GULF STATES UTILITIES COMPANY

River Bend Station Units 1 and 2
Docket Nos. 50-458/50-459

Enclosed are Gulf States Utilities Company responses to the open items identified in the Draft Safety Evaluation Report by the Auxiliary Systems Branch, responses to the request for additional information identified in part by Staff letters dated August 5, 1981 and December 31, 1981, and positions to the Licensing Review Group-II issues 1-ASB through 5-ASB. Attachment 1 of this letter summarizes the open items and indicates changes to be made in the River Bend Station FSAR. Attachment 2 provides a brief discussion of each open item, the response and reference material for each item. Where indicated, these responses will be provided in a future amendment to the FSAR.

ATTACHMENT 1

FIGURE 5.2-14b

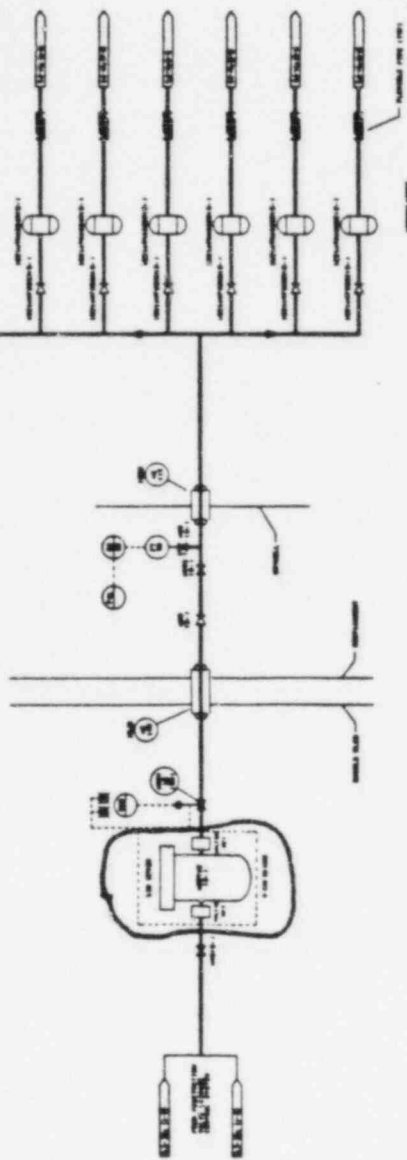
16. 9.3.1 The applicant should:
- a) show that the seismic Category, safety class, and quality group of the compressed air system piping and components that interface with the safety/relief valves.
 - b) verify that the compressed air supply for the safety/relief valves meet the requirements of ANSI MC 11.1-1976 with respect to dewpoint, oil or hydrocarbon content, and free of corrosive or hazardous contaminants.
 - c) commit to periodic testing to the requirement of ANSI MC 11.1-1976. (DSER Pages 9-72, 9-73, 9-75, 9-76).

- a. Both the PVLCS and main steam safety and relief valve air systems are Safety Class 2 and Seismic Category I. Their interface is shown on FSAR Figures 5.2-14b, 9.3-13a, and Table 3.2-1.
- b. The compressed air supply for the safety/relief valves meets the requirements of ANSI MC 11.1-1976. The requirements of ANSI MC 11.1-1976 are not applicable to the PVLCS and MS-PLCS air systems since they are service air applications, not instrument air. The revised response to FSAR Question 410.51 and additional revised FSAR sections describing the air systems are provided (Enclosure 15). This response will be incorporated into the FSAR in a future amendment.
- c. Periodic testing to assure high quality instrument air meets the requirements of ANSI MC 11.1-1976.

To be revised per description
in INSERT for Page 5.2-13a

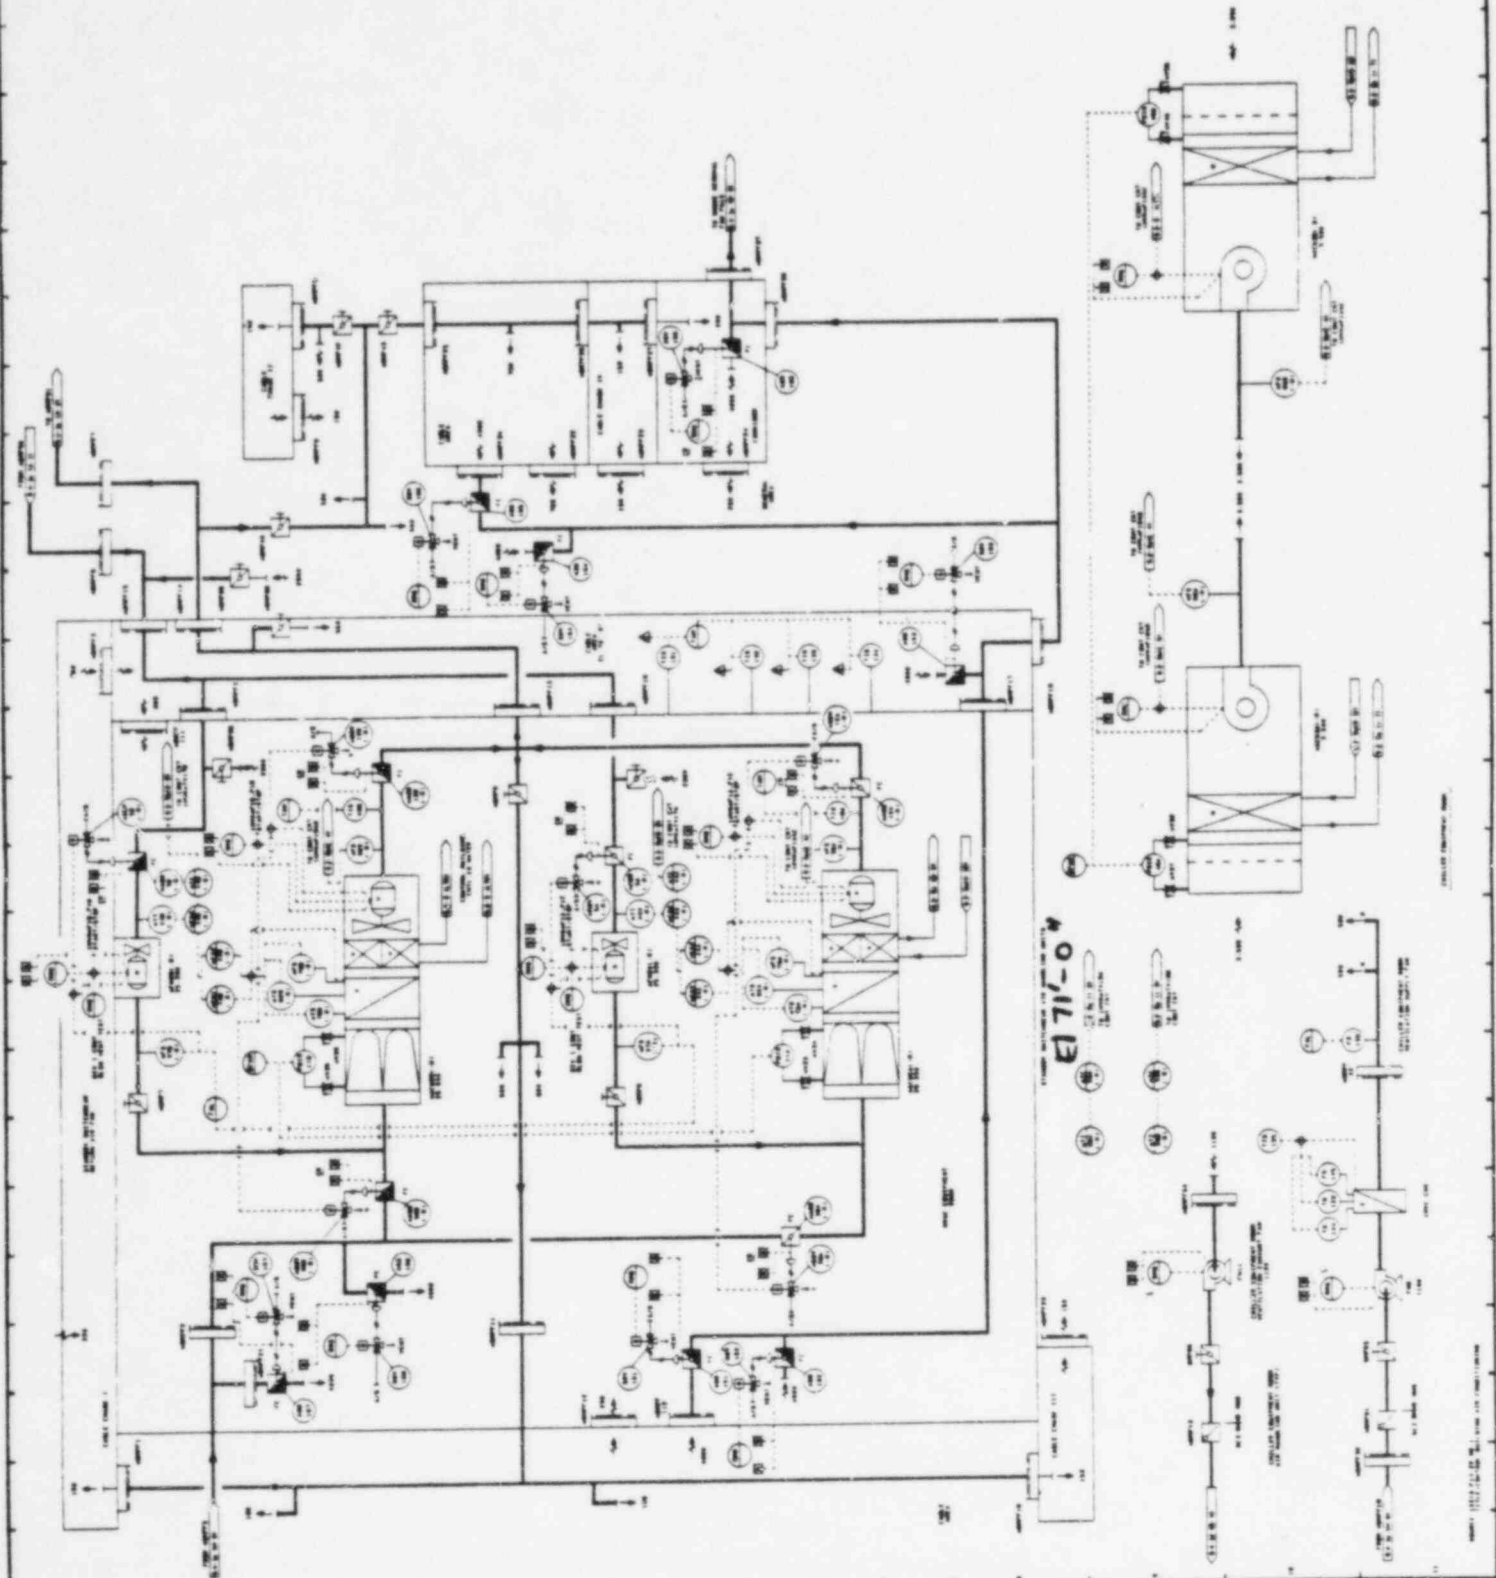
- a) revise the FSAR narrative and P&ID to indicate the locations of each of the standby switchgear room AC trains.
- b) provide a discussion of the significance of having two feedlines from the SSRAC system to battery room 1C while the other two rooms have only one feedline. (DSER Page 9-99).

- a. The standby switchgear rooms air-conditioning is located in the Control building at elevation 71'-0". See revised FSAR Section 9.4.1.2.2 and revised FSAR Figure 9.4-16 (Enclosure 21). This response will be incorporated into the FSAR in a future amendment.
- b. There is no significance associated with having two separate air intake lines to battery room 1C. This room

FIGURE 9.2-9a
CONTROL BUILDING CHILLED
WATER SYSTEM
PAID
RIVER BEND STATION
FINAL SAFETY ANALYSIS REPORT

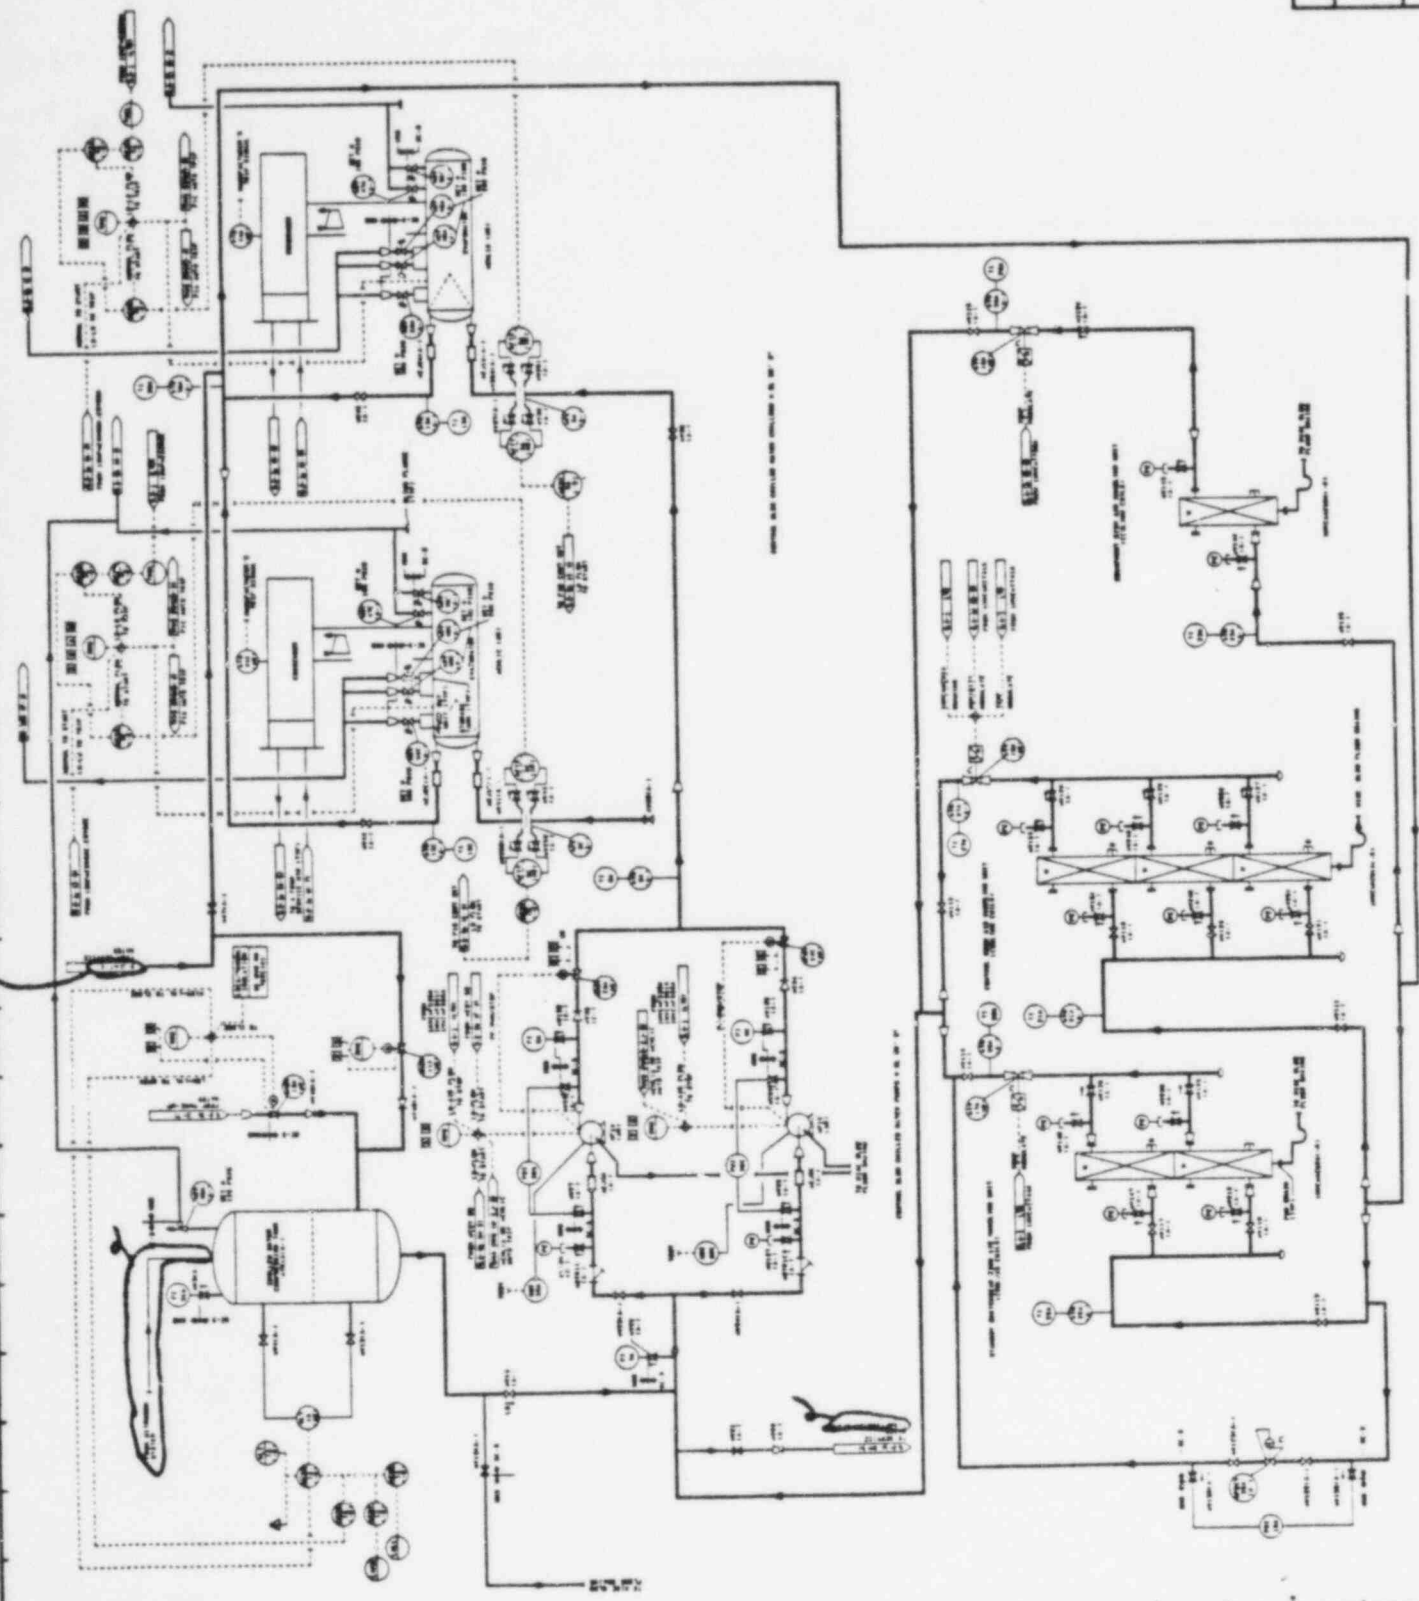
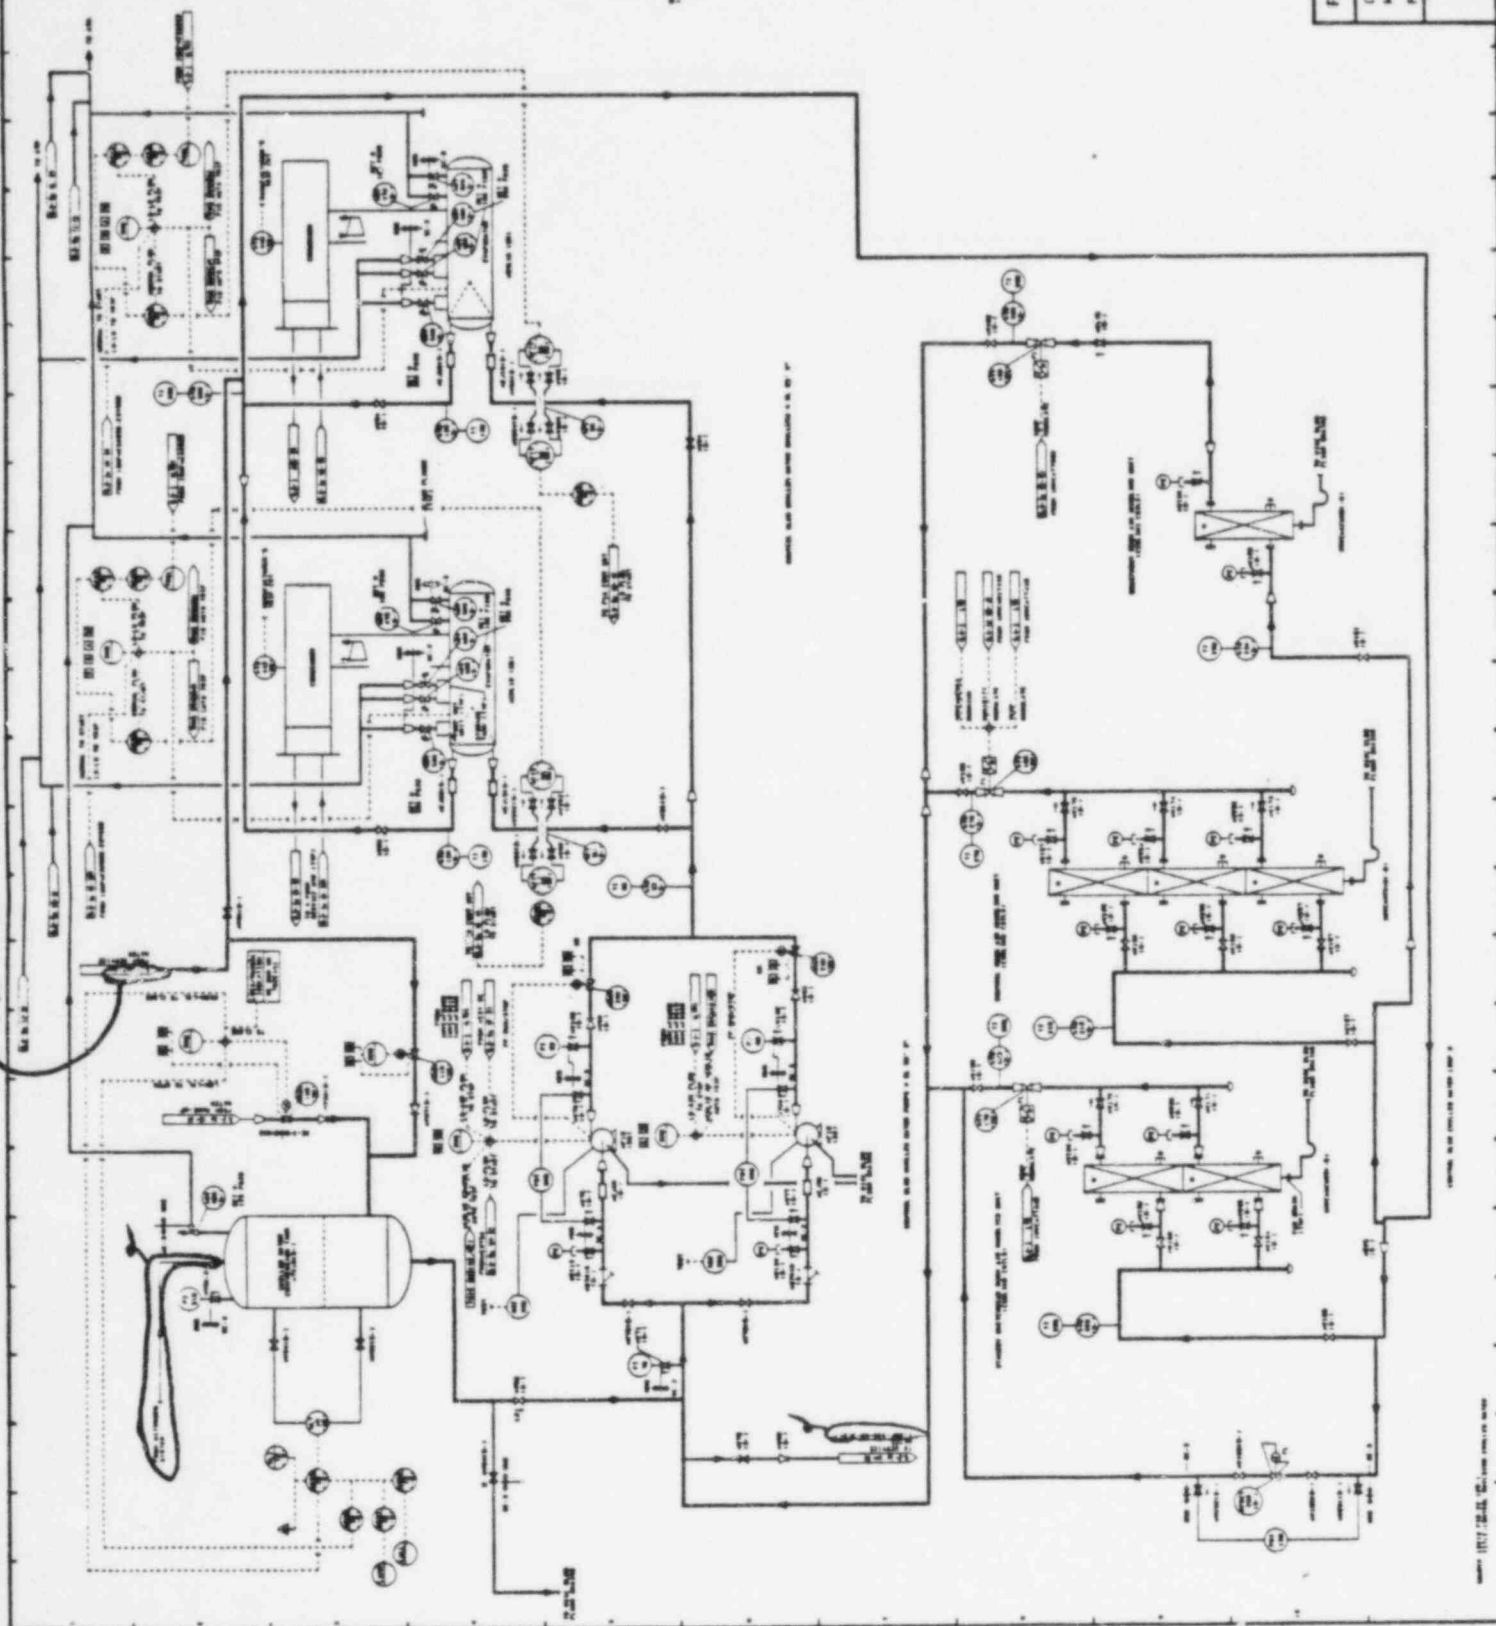
20. 9.4.1.4 The applicant should provide revised P&IDs to show the condenser cooling water pumps and the associated piping arrangements. (DSER Page 9-103).

The condenser cooling water pumps are shown on Figure 9.2-1a, Zones 5-I, 7-I, 9-I, and 10-I.

The cross-ties between the control building chilled water system and the standby service water system are shown on revised FSAR Figures 9.2-9a and 9.2-2b, Zones 2-E and 7-B. (Enclosure 22). The revised figures will be incorporated into the FSAR in a future amendment.

ENCLOSURE 31

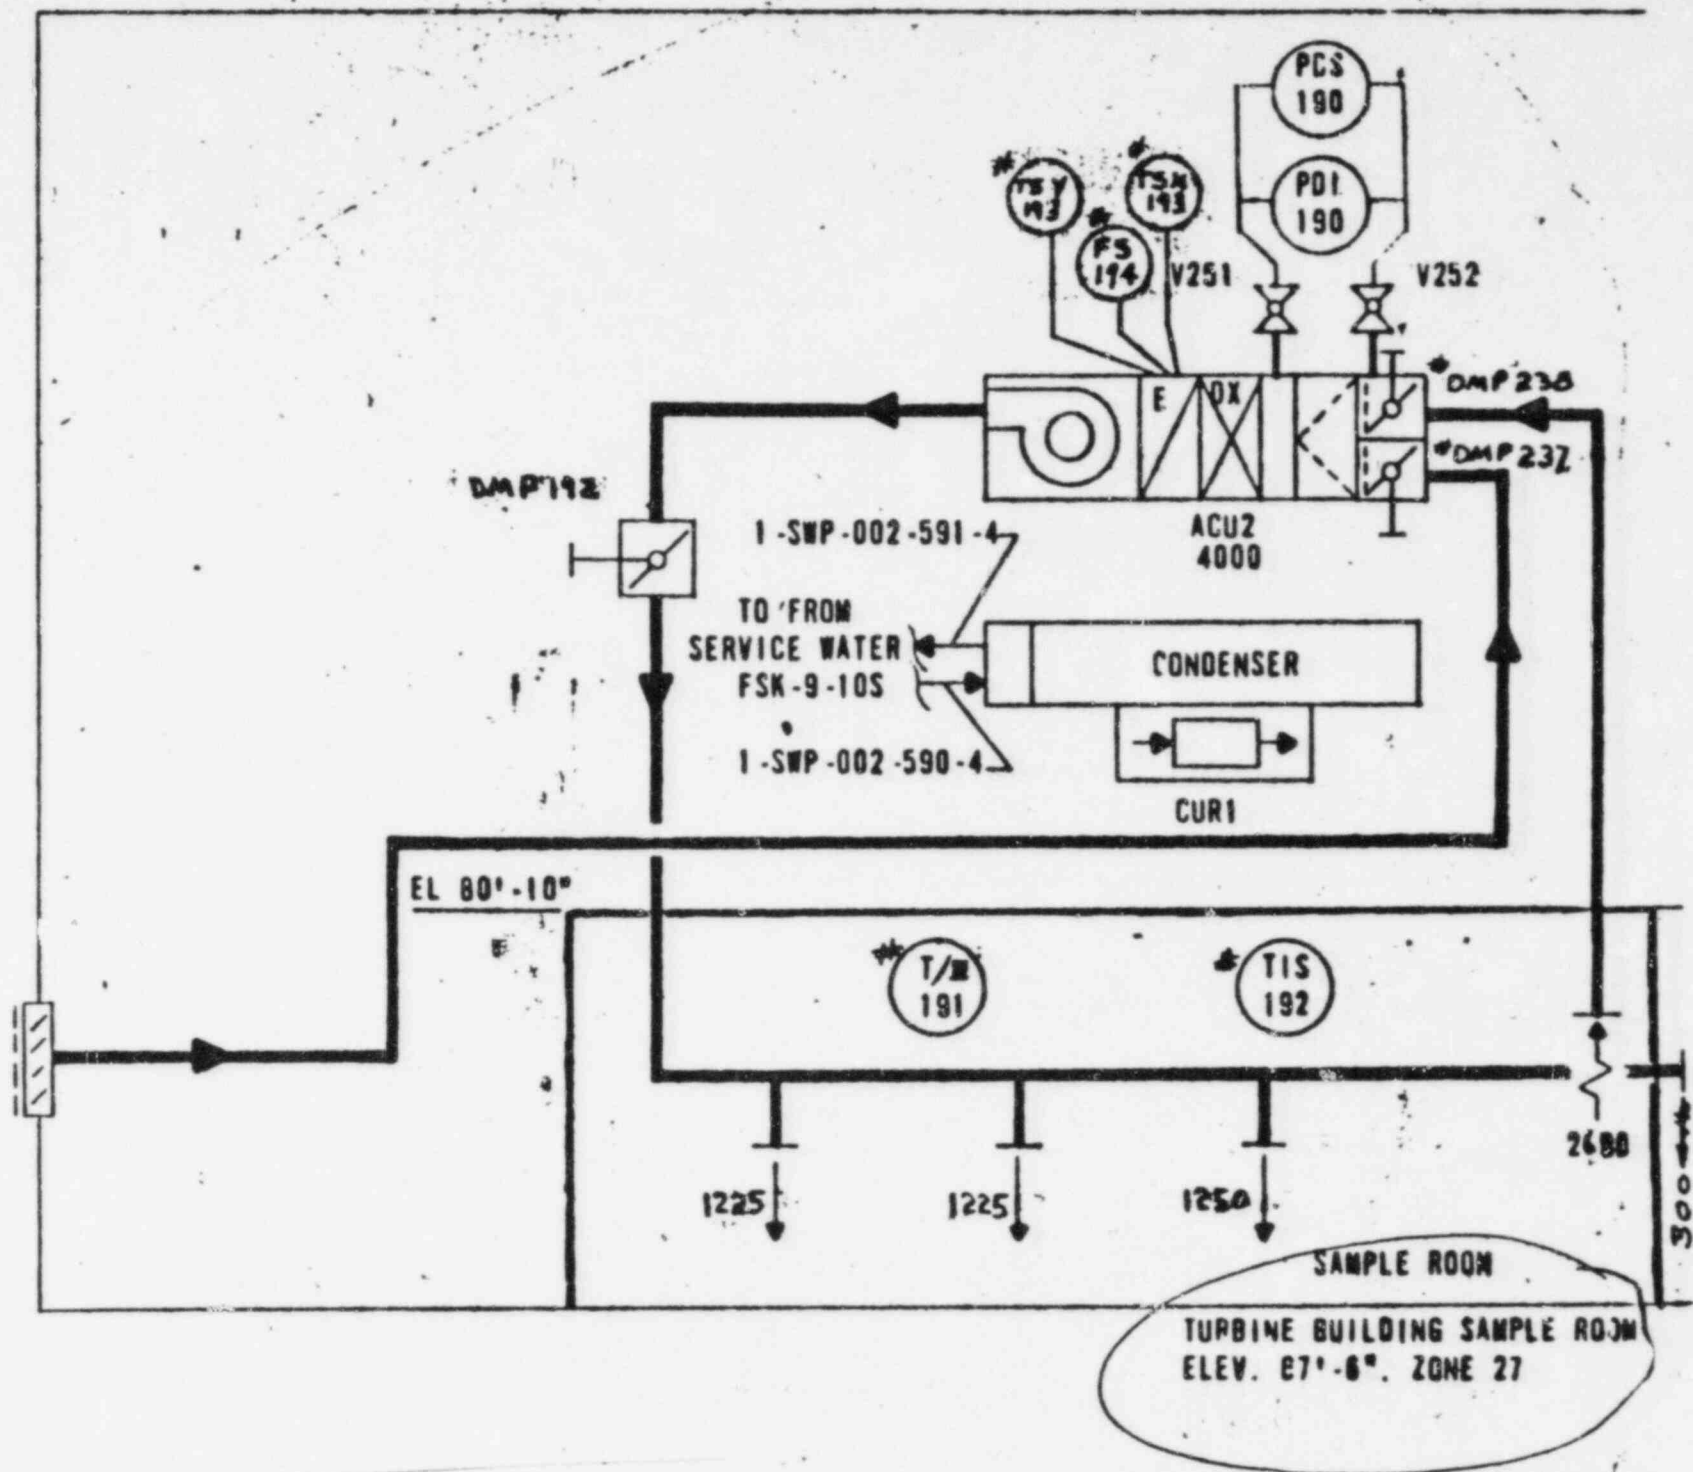
- a) provide detailed information to show compliance with Regulatory Guide 1.140, Positions C.1.a through C.1.d, C.2.a through C.2.c, and C.2.e.
- b) revise P&ID Figure 9.4-4 to include the sample room HVAC system and appurtenances.
- c) provide a discussion which shows that the system meets the guidelines of Regulatory Guide 1.29, Positions C.2 and C.3. (DSER Pages 9-121, 9-134, 9-135).

- a. See the response to Item 22(c), which also applies to the charcoal filtration system in the turbine building ventilation system.
- b. A drawing is provided of the turbine building sample room HVAC system (Enclosure 31). Figure 9.4-4b will be revised and incorporated into the FSAR in a future amendment.
- c. The turbine building ventilation system (TBVS) is located within the turbine building. The building is a non-Seismic Category I structure. As noted in FSAR Section 9.4.4.1, all components of the TBVS are non-nuclear safety-related, nonseismic, and are not required to operate following a DBA. Regulatory Guide 1.29, Positions C.2 and C.3, are not applicable to the TBVS.
